Agenda
Village of Arlington Heights
Design Commission
Community Room, 3rd Floor

STAFF DESIGN COMMISSION REPORT RE-REVIEW

Project Name: 915 S. Dunton Avenue
Project Address: 915 S. Dunton Avenue
Prepared By: Steve Hautzinger

DC Number: 18-024
Petitioner Name: Daniel P. Poloz
Petitioner Address: 1567 Ridge Avenue, Unit 603
Evanston, IL 60201
Original Meeting Date: April 10, 2018
Re-Review Meeting Date: April 24, 2018

ORIGINAL DESIGN 4-10-18

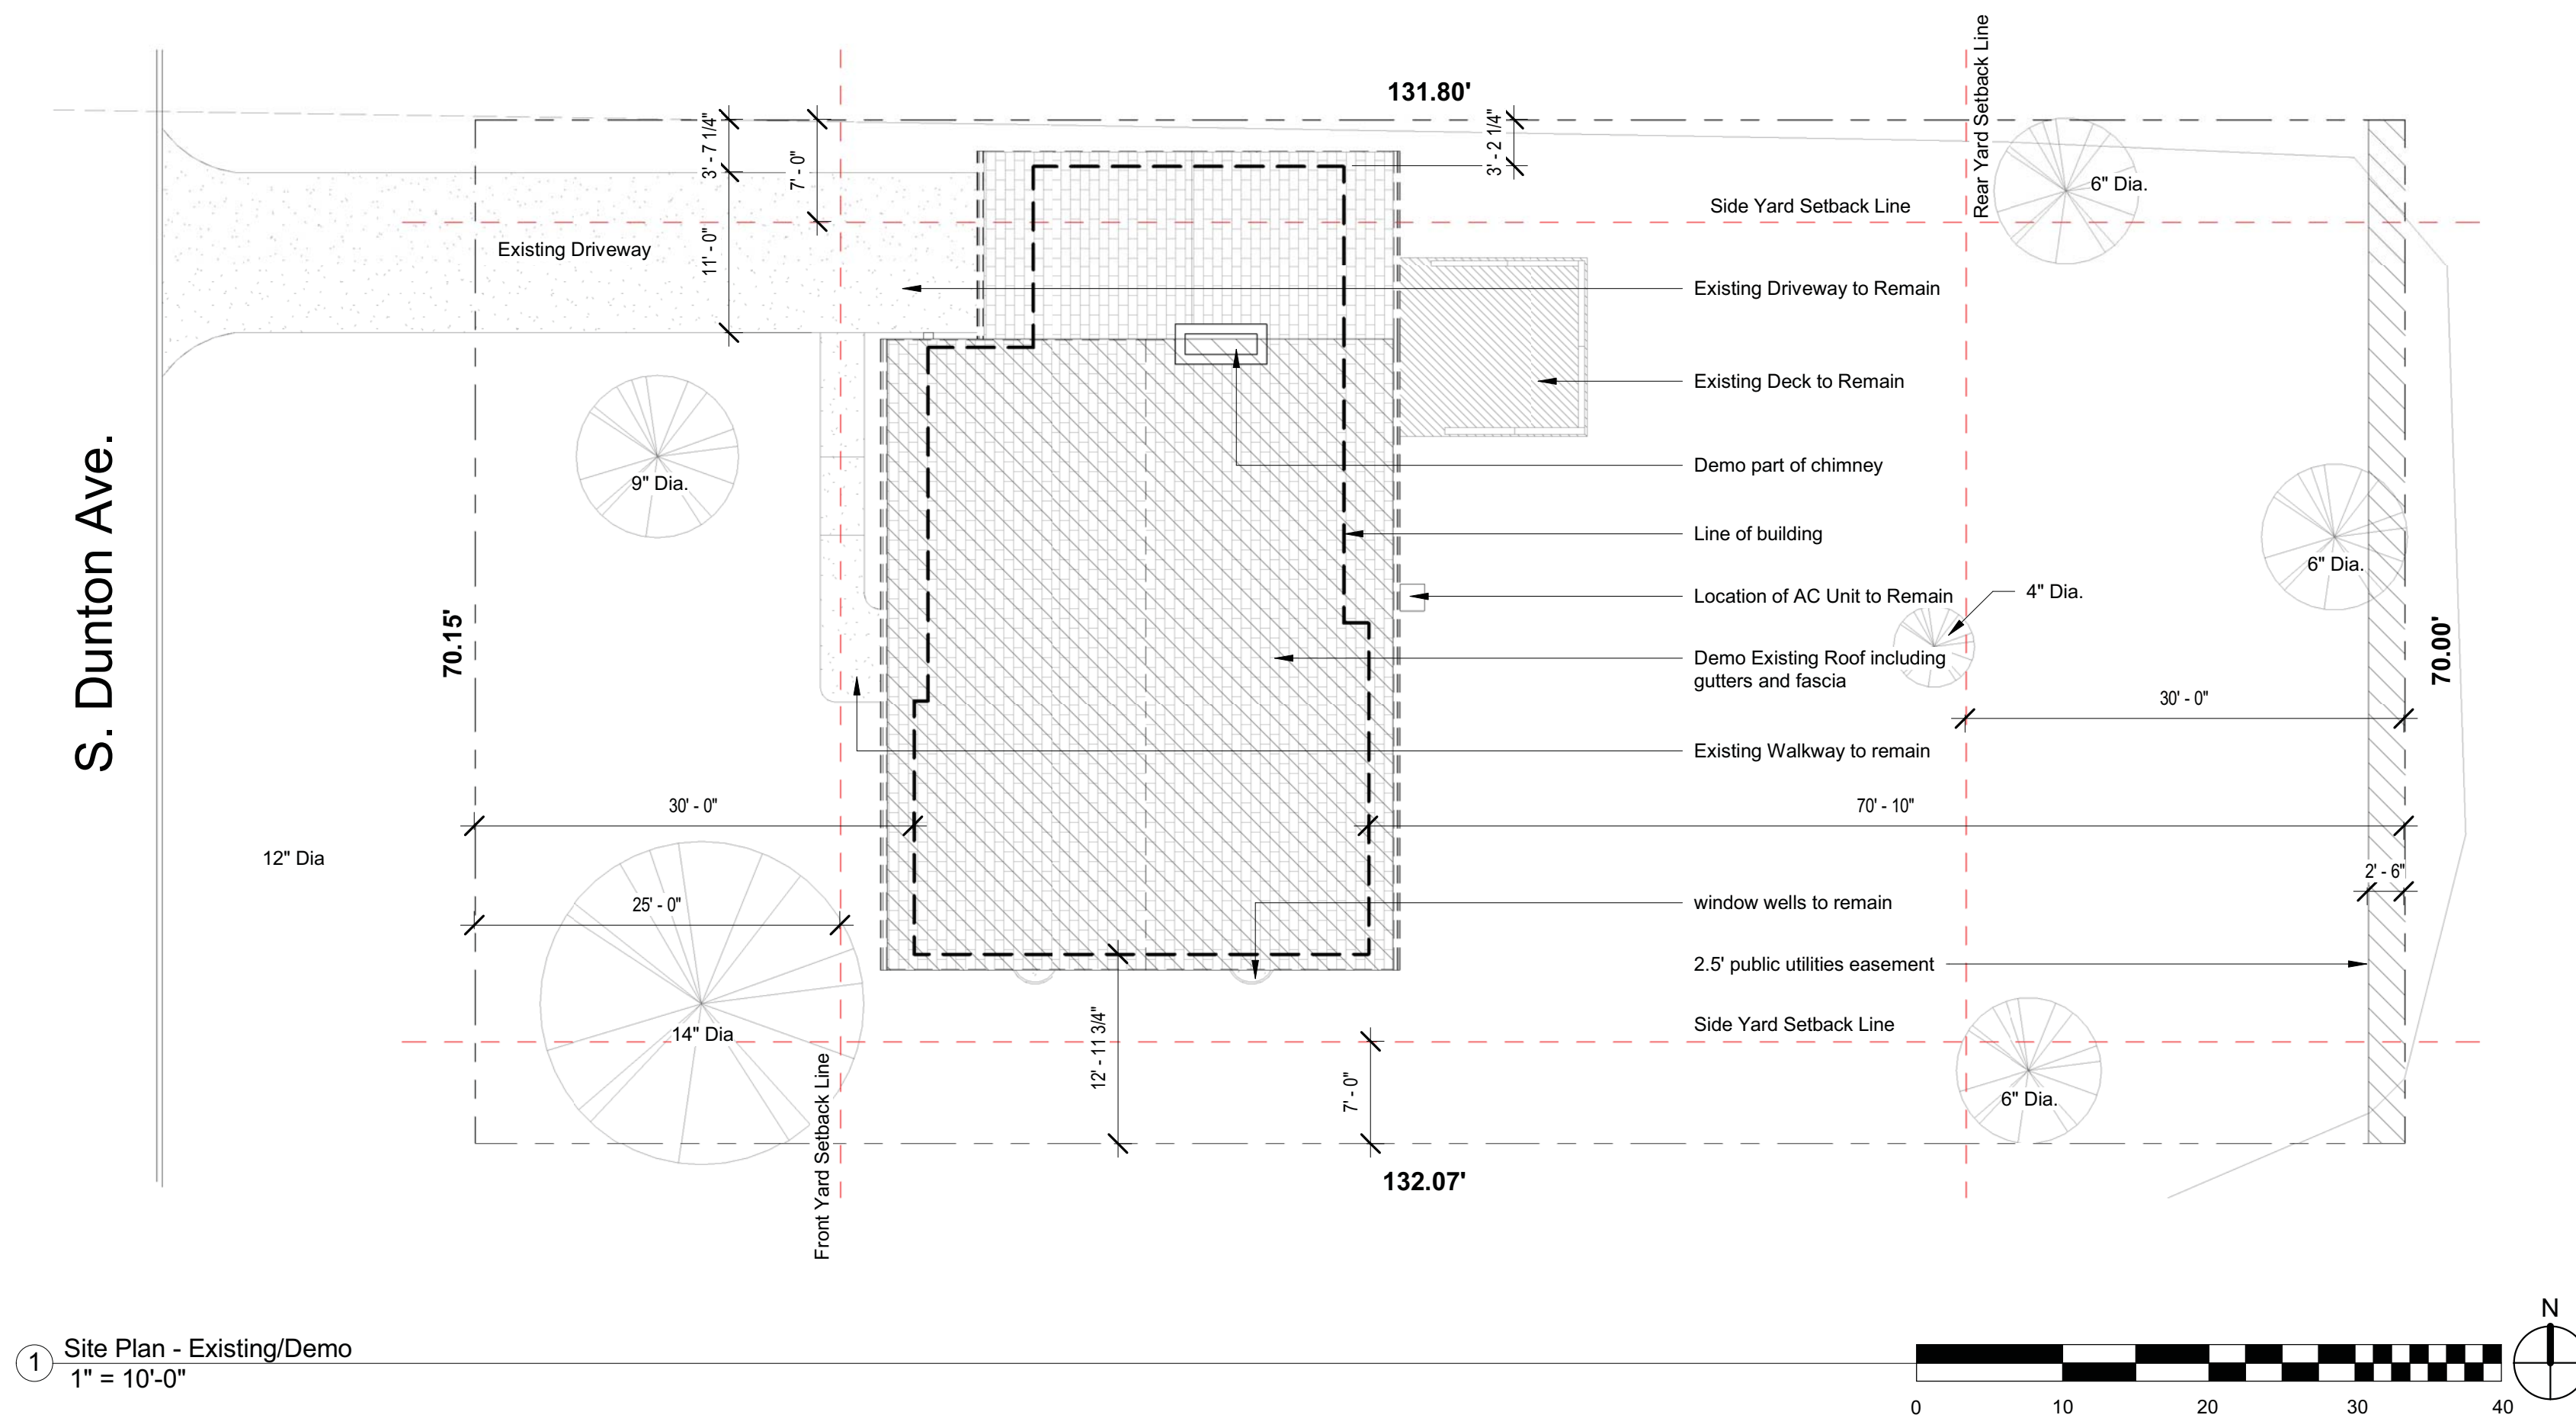
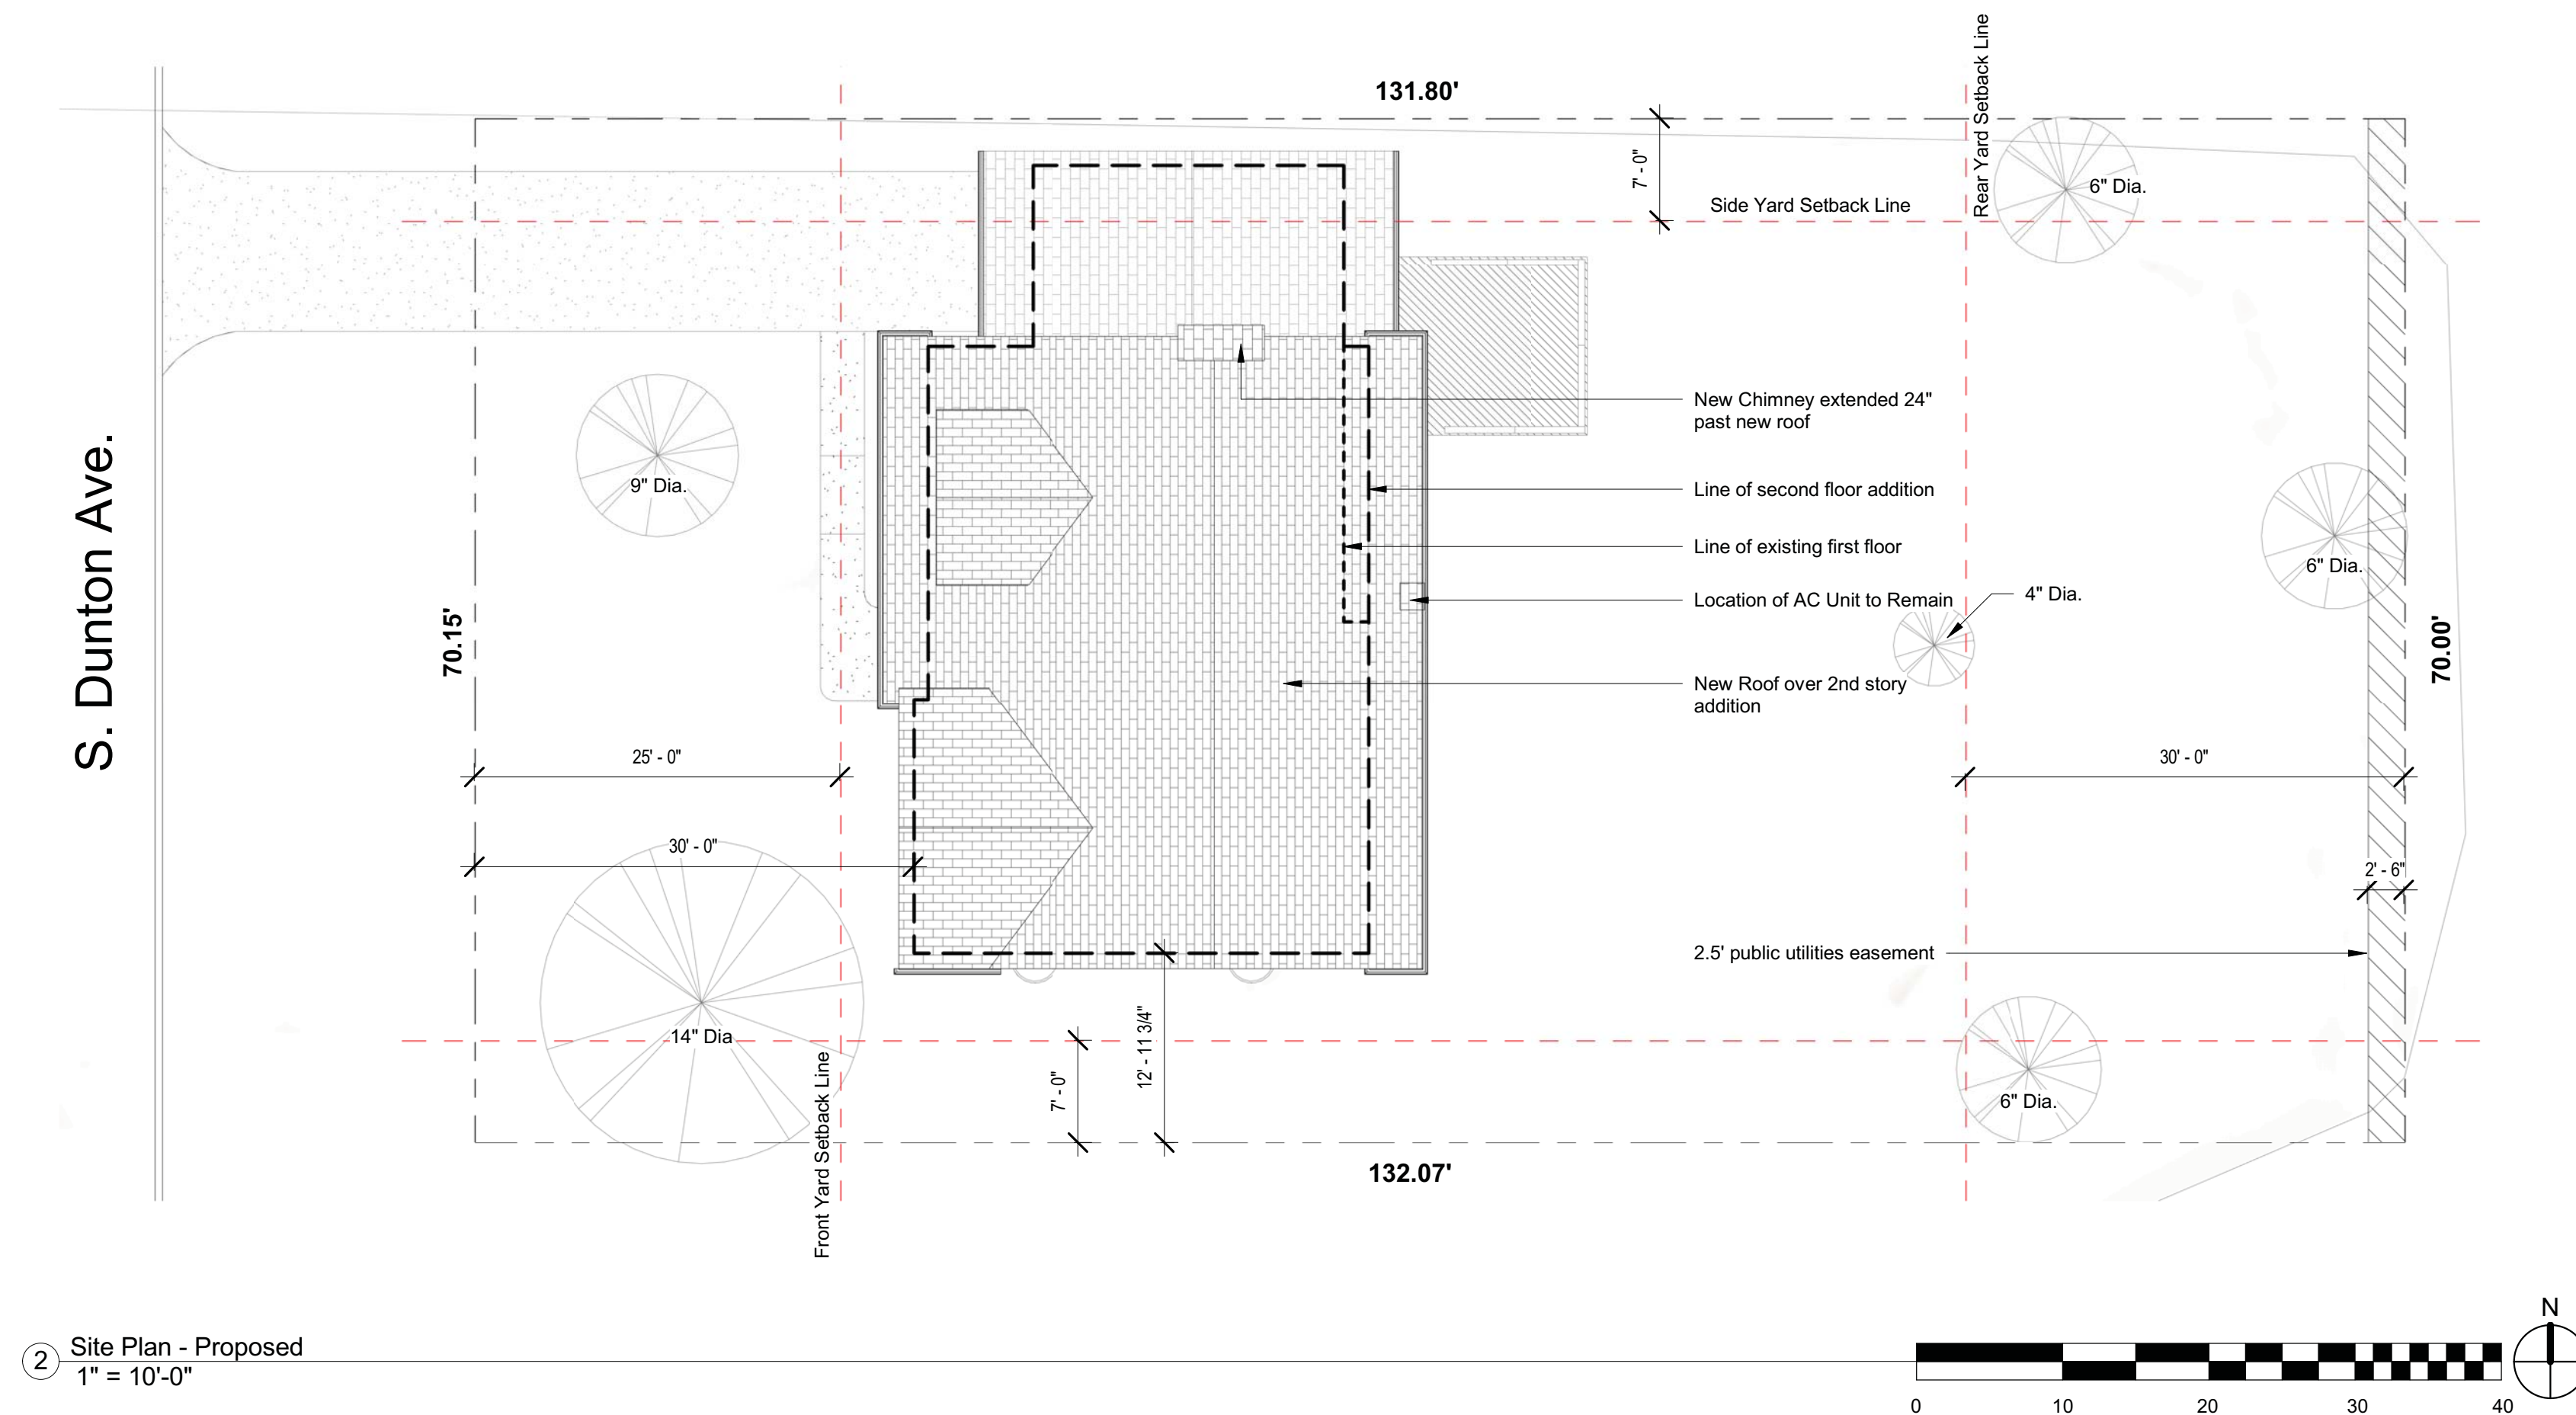
The overall scale of the proposed second floor addition fits well in the context of the neighborhood, but the massing of the proposed design has awkward proportions. The front gable wall, roof dormer, kitchen window, and front door do not complement each other and they have a mismatched appearance.

- Adjust the roof slopes to lower the eave on the left side of the front elevation to more closely align with the existing garage eave.
- Lower the dormer to align with the adjacent gable, and change the dormer windows to match the windows on the right side of the front elevation.
- Change the kitchen windows to more closely match the windows on the right side of the front elevation.
- Omit the field of stone around the kitchen window, but keep the stone base.

Commissioner Kingsley commended the petitioner for doing something unique and different for his home. She agreed with some of Staff's comments, and she really liked the back of the home; however, she felt there was tension in the front elevation. She liked that the center entry has the 2-story space and it is accentuated, but she agreed with Staff that there is a void above the kitchen window; bringing the eave down or doing something in that location would really help. She liked the 2-story element on the right, as opposed to the left side, but felt it could be a little stronger and more developed. She agreed with Staff's comments about the windows, and wanted to see some of the same expressions in the windows, at least on the front elevation. Commissioner Kingsley felt the dormer in the loft was a good idea but it could be a lot stronger if the windows were mulled together, and the roof element needed more development. She agreed with Staff about the stone; it needs to be better detailed or stopped at a certain point; perhaps just a surround around the kitchen window. She understood the petitioner wanting to keep the existing kitchen window, but suggested painting the window to relate to the new windows. She was also leery of the panels between the glass on the right side of the front elevation; a large panel may not weather well, and how the panel is detailed is important.

Commissioner Kingsley also said that the rear elevation had a completely different feel, looking more like a modern 2-story, which she liked; however, the front elevation did not have the same feel and needed more development. She acknowledged the lower height of the garage being proposed adjacent to the one-story home, but felt the eave height should still come down over the front door.

Overall, Staff feels that the revisions have addressed the primary concerns, and the revised design now has a cohesive appearance. It is recommended that the fascia and soffits on the garage be coordinated to match the detailing on the house.
